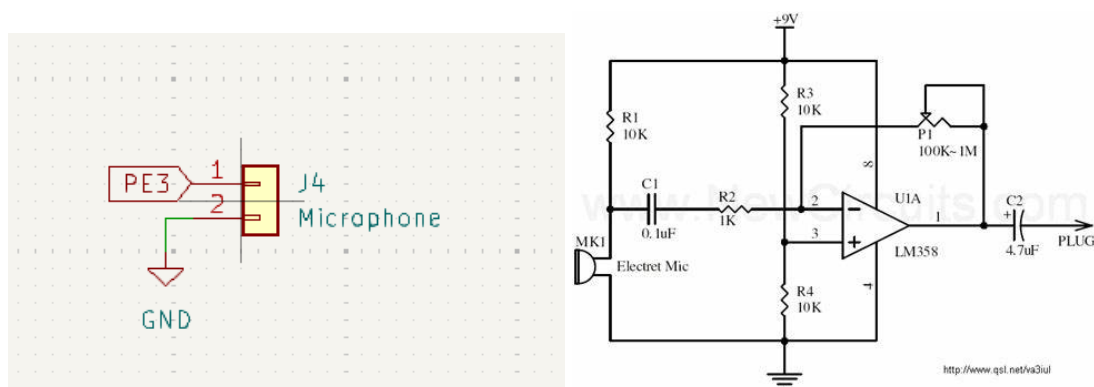
9V to 3.3V is a significant loss of energy. About 2/3rds of the battery power will be dissipated as heat. Consider using a USB power source instead.

Consider using a breakout board for the accelerometer instead of the discrete IC. Should the CS for MAX and XL both be tied high? Are you intending to use I2C?

Making a direct connection between microphone and analog input won't work out well. You're definitely going to need to amplify the signal and maybe some degree of filtering. Typically microphones act as variable resistors, so you need to create a voltage divider with them. Additionally, since this voltage is not about the center voltage, you will typically add a bias circuit. After this you will also normally amplify the signal. An example of this is on the right, but we would recommend you look at the circuit given in lab 9.

When using the 9V battery you have multiple drivers of the 3v3 line which will cause an issue. There is a regulator on the launchpad that will step down your VBUS to 3.3V, but you also have a separate regulator that also steps down to 3.3V. These should **not** tied together.
